**ADDENDUM NUMBER TWO**

**DUPONT PUMP STATION AND BASIN IMPROVEMENTS – PHASE 2 (Contract A)  
W-12-026-202**

**CITY OF CHATTANOOGA, TENNESSEE**

The following changes shall be made to the Contract Documents, Specifications, and Drawings:

Attachment A to 13 60 13 - 4  
 Pre-Fabricated Restroom

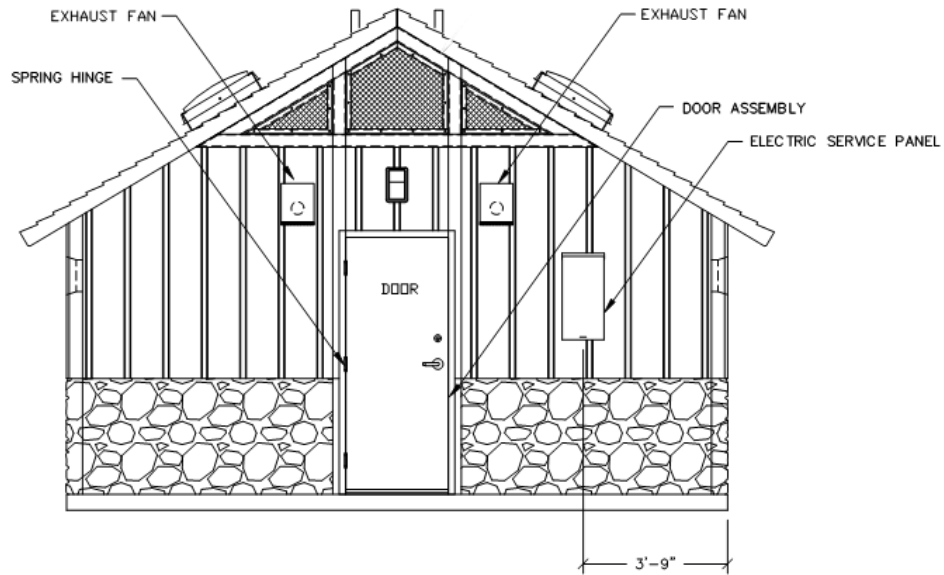
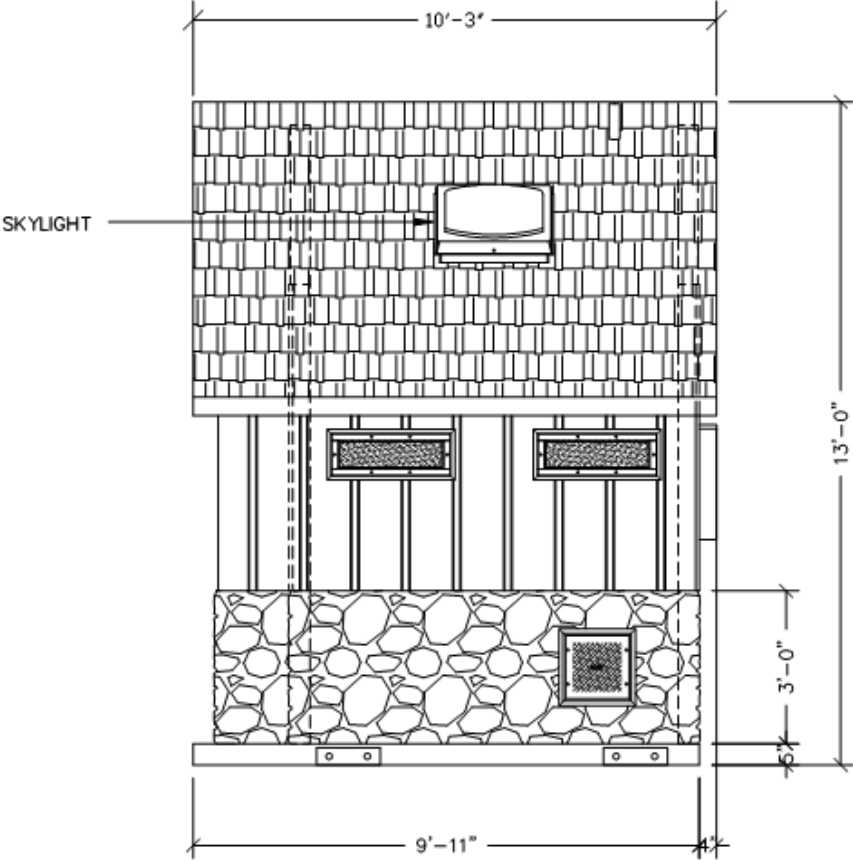
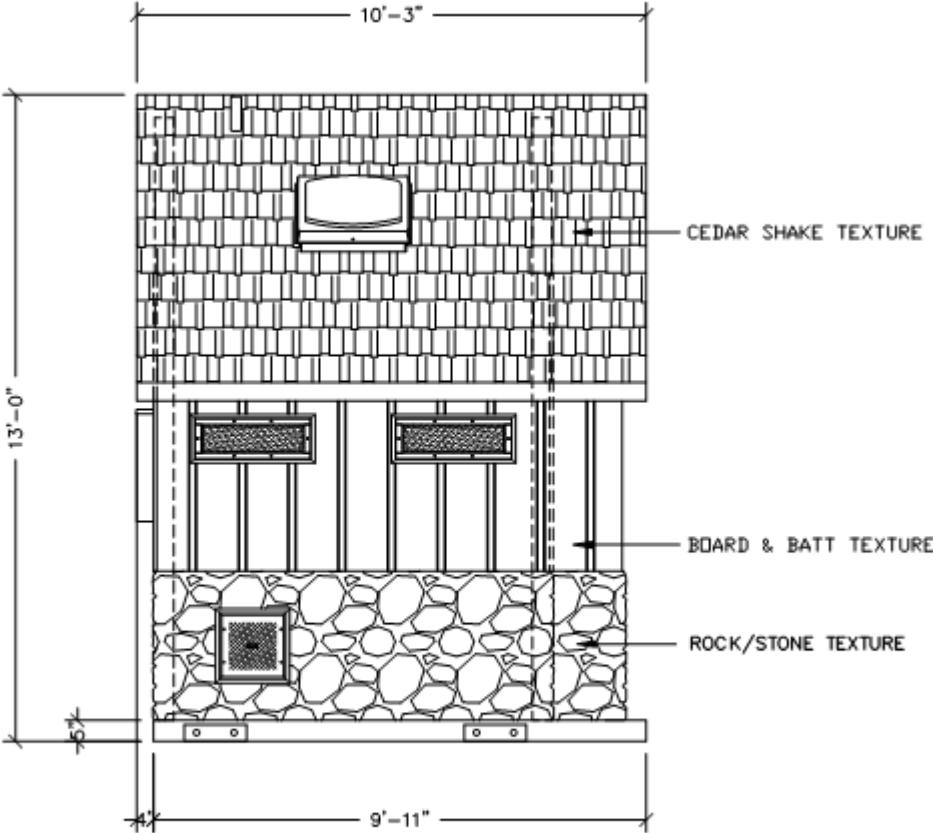
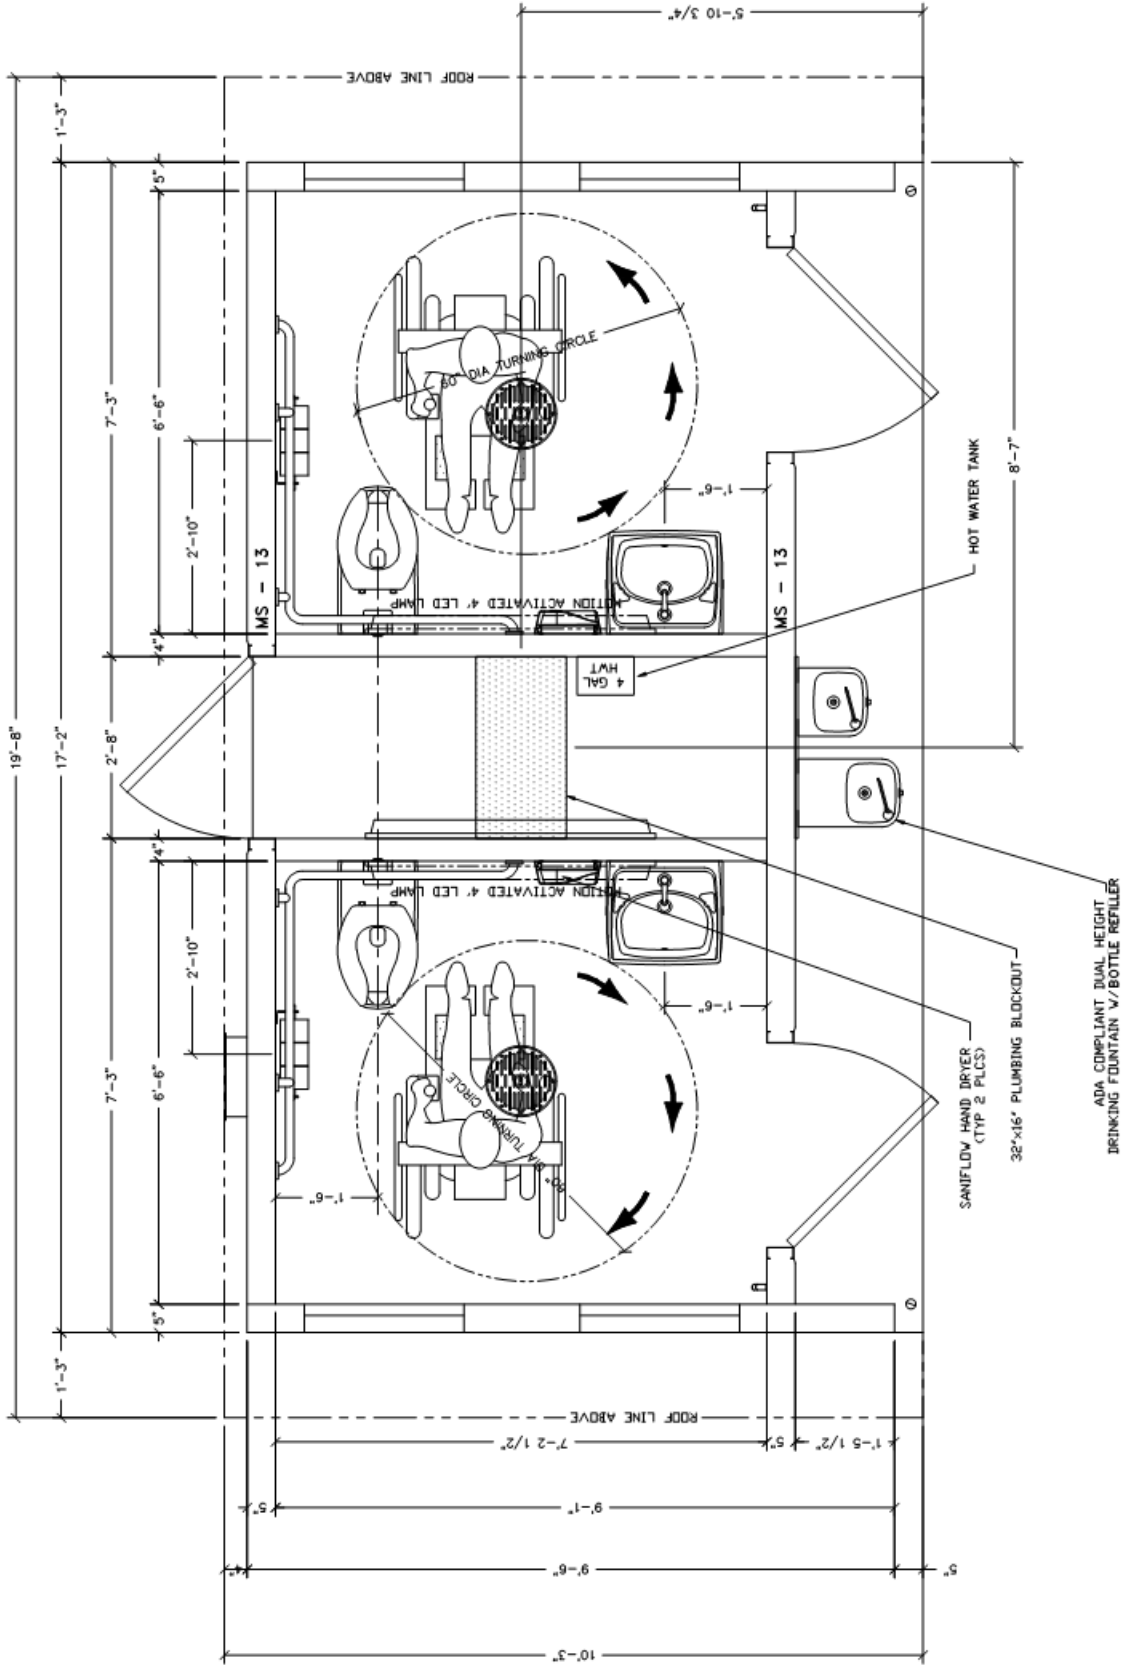
- Add “Attachment A to 13 60 13 Pre-Fabricated Restroom” to Section 13 60 13 Pre-Fabricated Restroom.
- Geotechnical Report prepared by CDM Smith is attached, appendices are included in Addendum No. 1. Contractors may rely on the data presented in this report. However, reliance on any interpretations of such data are at the Contractor’s sole risk.
